Revision of Manuscript Number: IEEE-TPWRS-01391-2021, version 1 February 28, 2022

Journal: IEEE Transactions on Power Systems

Author: Abhishek Halder, Kenneth F. Caluya, Pegah Ojaghi, Xinbo Geng

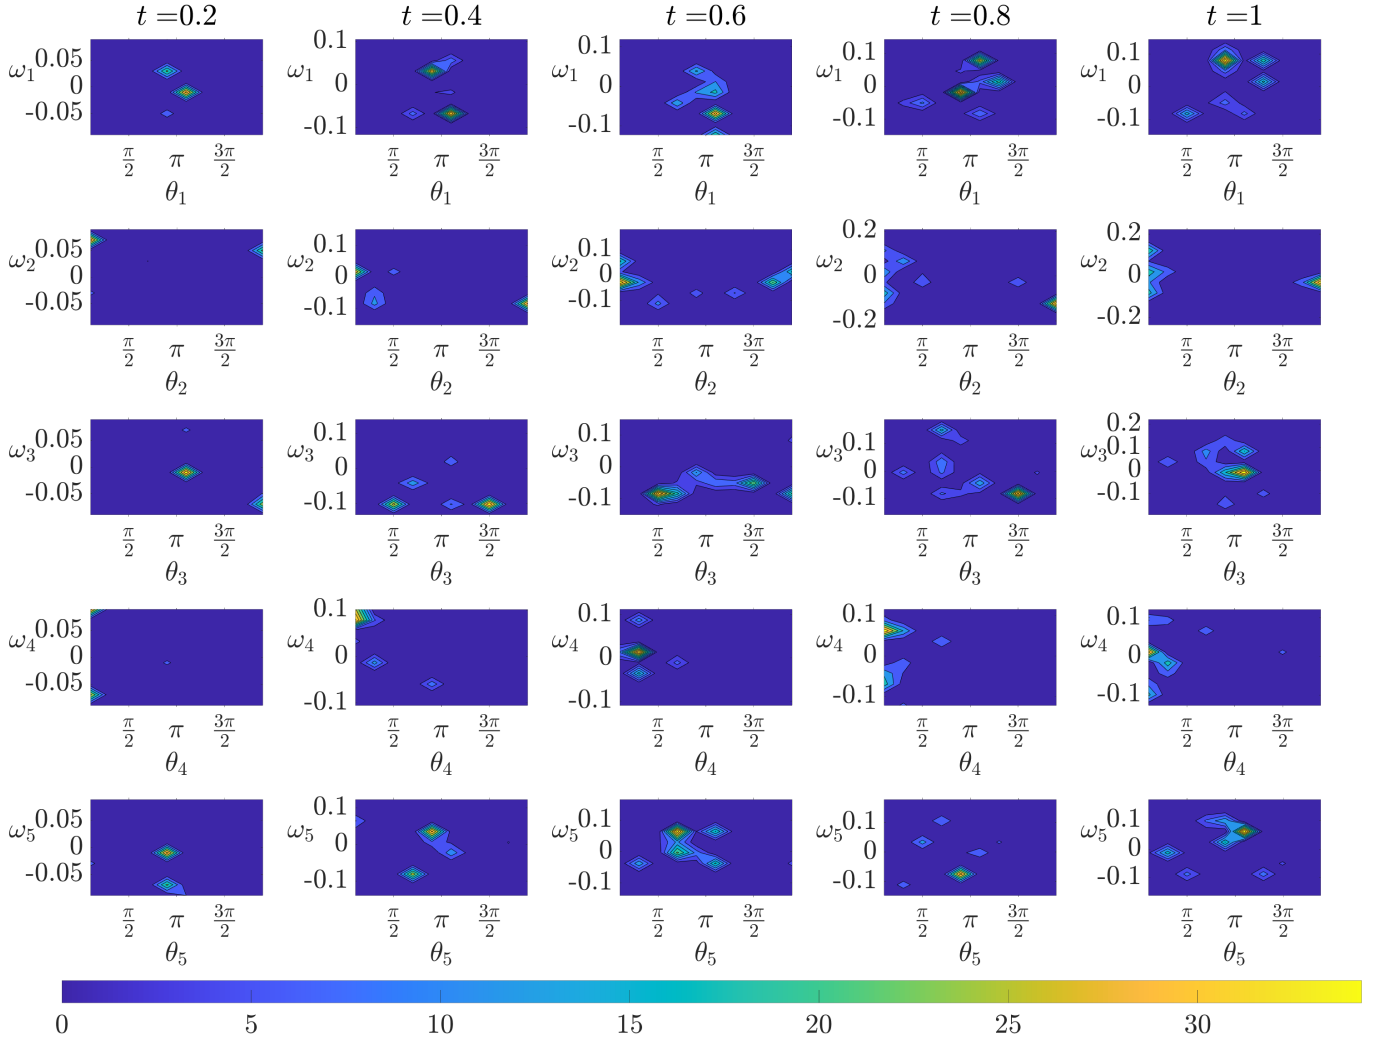
Figures 5 and 6 are unreadable.

Response: Thanks for this comment. In the previous version, the strict 10 page limit enforced small figure sizes. In the revised manuscript, Figures 5 and 6 are made larger. Also, the Fig. 6 in the revised manuscript shows the transient (θ_i, ω_i) bivariate marginals for all the five generators in Case II; the previous version showed the same only for the generator 4 (bus 6). We believe these changes have improved clarity.

Regarding the style of plots, we had considered plotting the bivariate marginals as planar contour plots (as in Fig. 1 in this rebuttal document) but decided against it because of the following two reasons.

First, in our opinion, this kind of plot is scientifically misleading as they hide the fact that these bivariate marginal PDFs are not really supported on the plane, or the subsets thereof, but instead have cylindrical supports. Our message that the proposed method explicitly accounts this manifold geometry in the computation, would be missed had we chosen to make the plots the other way.

Second, the planar contour marginal plots require additional mental efforts from the readers to correctly parse the statistical information conveyed. For instance, consider the fourth column, second row subplot in Fig. 1 in this rebuttal document. It is upon the reader to parse that the two high probability regions on the left and right of that subplot are actually referring to the same angular high probability region around $\theta_2 = 0$ rad, thanks to the periodic boundary condition on the angular variable. Our philosophy of technical communication is that the onus is on the authors, not on the readers, to clarify the scientific information as correctly as possible. We thus prefer to make plots that depict the variables as they are.
